BAR Meeting
September 7, 2016

ISSUE: Permit to Demolish and Certificate of Appropriateness for Alterations

LOCATION: 716 Queen Street

BAR2016-00263 & 2016-00264

Figure 1: The applicant's preferred initial scheme. Note the addition of a central window to the second story.

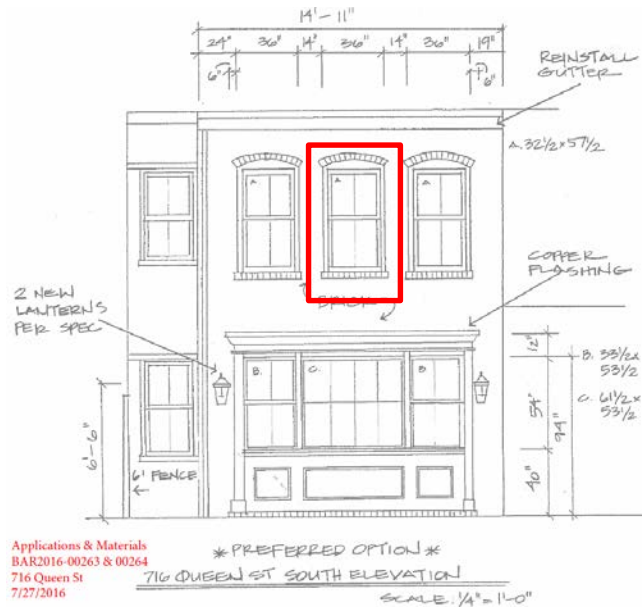
The applicant’s design for the altered elevation has evolved since speaking with BAR Staff. Originally, the applicant desired the addition of a third, centralized window between the two existing windows on the second story (Figure 1). This would have necessitated moving the apertures of the original two windows farther apart in order to achieve symmetry. The applicant, however, also provided an alternative design in her original submission that left the second-floor portion fenestration intact (Figure 2). Because this upper portion of the elevation is visible from the Lloyd House garden, and because adding a third window to a two-bay elevation would be unconventional, staff advised the applicant to choose the alternate scheme.

Figure 2: The applicant's alternate scheme, former submission. Note second story left in situ.

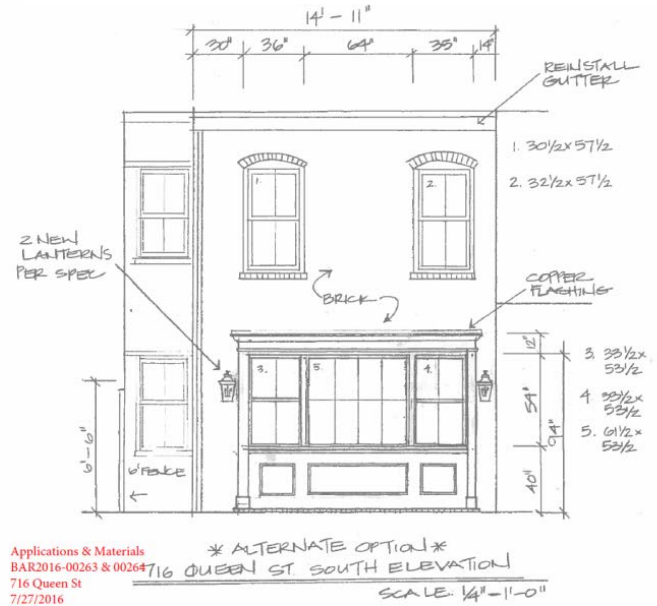
The applicant’s latest submission (Figure 5) keeps the second-floor portion’s fenestration pattern as it currently is. The BAR has noted in previous projects that where a row of historic ells remain relatively unaltered and are visible from the public way, it is preferable to retain as much of the material, form and design as possible in order to convey these historic secondary spaces. Since the majority of the adjoining townhomes on Queen Street have unaltered rear elevations, it is preferable to keep the visible second-story elevation on this dwelling intact as well.

Figure 3: The applicant's first-floor fenestration pattern associative image, former submission.

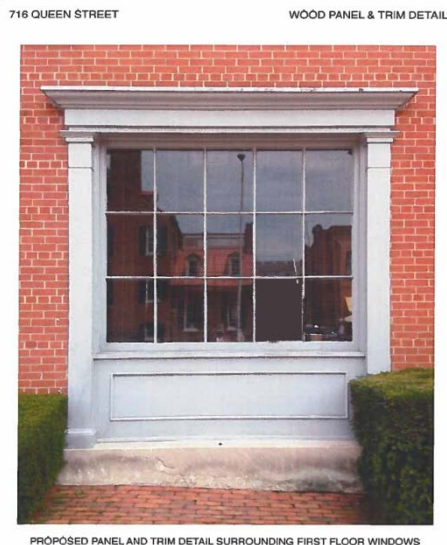
In regards to the first-floor, the applicant originally wished to alter the current fenestration by replacing the two segmental arch apertures with a large, multi-light window with wood trim, including pilasters, architrave, and panels (Figures 1 and 2). The applicant's associative image, included in her original submission, was a storefront window found at a local bank (Figure 3). Her inspiration was a modern, industrial curtain wall incised into a historic townhome (Figure 4).

Ultimately, the applicant's functional goal is to maximize the amount of natural light that can be filtered into the first-floor interior. Because the first-floor portion of the southern elevation is obscured from public view by a six-foot privacy fence and mature trees (which also diminish the interior's access to sunlight), there is more freedom to experiment with fenestration forms and patterns which would aid the homeowner in improving daylighting. However, staff advised against the proposed first-floor fenestration originally submitted as typologically and stylistically inappropriate (the Colonial Revival-style trim and multi-pane windows are not suited to a Victorian period structure, nor is a commercial storefront window suitable for a residence).

Figure 5: The applicant's preferred scheme for first-floor fenestration. current submission.

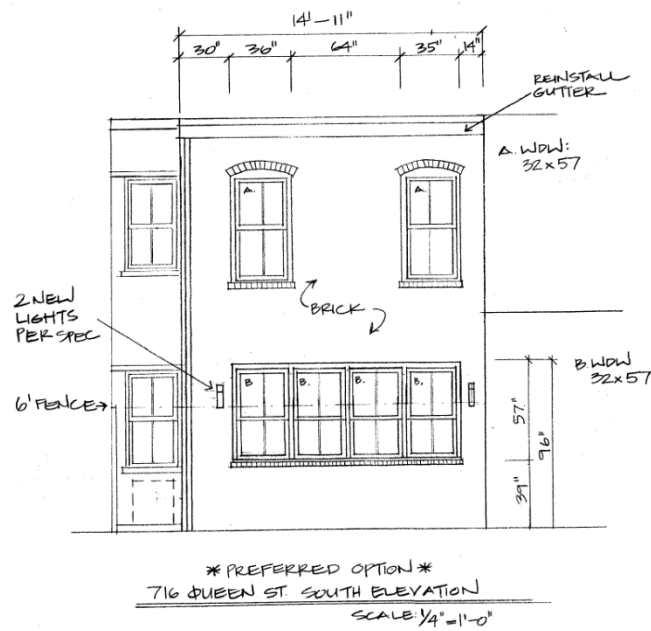
If the applicant’s alternate option is the most conservative approach to this design query and the industrial curtain wall (Figure 4) which inspired the applicant could be said to be the most radical approach, there is a middle ground found in the applicant’s preferred option (Figure 5). This is also a more elegant and simple solution than her original submission with Colonial Revival style trim, and this fenestration pattern potentially maximizes the amount of daylighting while retaining a larger portion of the historic masonry (Figure 5). Here, the applicant has eradicated the segmental arch forms yet kept the brick row-lock which visually connects the window sill with the upper-story sills. The applicant has created a continuous span across the majority of the elevation’s width by ganging four two-over-two double-hung windows in a late-Victorian style. The aperture height is maintained, as is the historic sash light configuration, while the end windows vertically align with the upper-story apertures.

However, the preferred alternative in Figure 5 lacks any visual structural support above the windows. A brick jack arch is stylistically inappropriate and would not structurally span this width. This lintel is an important feature, as it is the primary element that will be visible above the fence. A flush wood lintel, a minimum 8” tall, would be appropriate. Staff also suggests that the applicant consider a steel, C-channel lintel for this window span, which would add a visual demarcation to the aperture as well as allude to the applicant’s industrial inspiration. The successful use of such metal lintels on a historic structure can be seen at 210 North Lee Street (Figure 6).

1. Approval of the Permit to Demolish.
2. Approval of either the applicant's preferred option or the alternate option for the first floor windows, as directed by the BAR at the hearing. If the applicant's preferred option is selected, the windows must have a wood or metal lintel with final details to be reviewed by staff prior to release of a building permit.

REAR WALL (SOUTH ELEVATION)

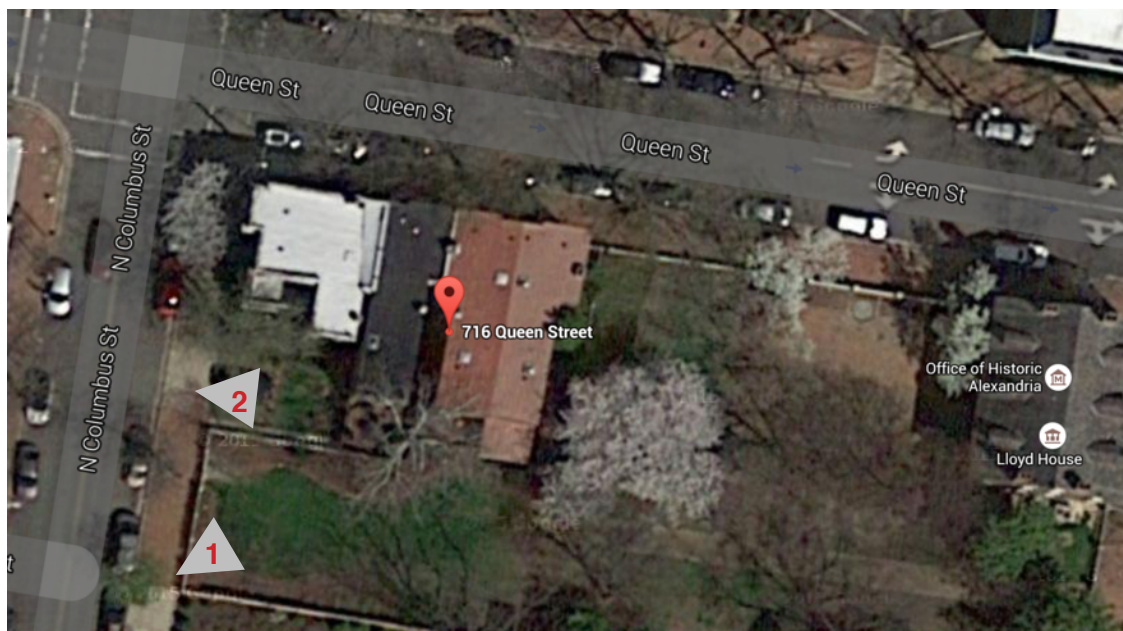
Although the BARs “prefer the amount of demolition be limited to that necessary... rather than wholesale demolition and replacement of the rear façade,” BARs do take into account compelling reasons for demolition, such as lack of structural integrity. Staff recommends that the applicant retain and preserve in place as much of the upper south wall and its materials as possible. However, as water damage and deferred maintenance have resulted in its severe deterioration, to the point of it becoming structurally unsound, staff supports carefully dismantling the historic rear wall as necessary.

Staff also supports the applicant’s intent to rebuild the wall using salvaged and historic bricks with lime putty mortar. Whereas the BARs routinely permit partial demolitions or encapsulations of rear walls for additions, this project will largely reconstruct the historic fabric and leave it exposed, thereby retaining the house’s form and footprint and building materials intact and visible. Staff recommends that the mason replicate the existing 7:1 common bond pattern that distinguishes the rear elevation.

5. The applicant will retain as much of the original brick as possible and use bricks salvaged from the deconstruction of the south elevation to reconstruct the southern (rear) wall; if historic bricks are acquired from another source, they must match the existing historic bricks in color, size, and texture.

6. The mason will provide a mock-up sample of hydraulic lime mortar which matches the original mortar in color, tooling and composition. The mock-up must be approved by BAR Staff on site prior to commencement of work.
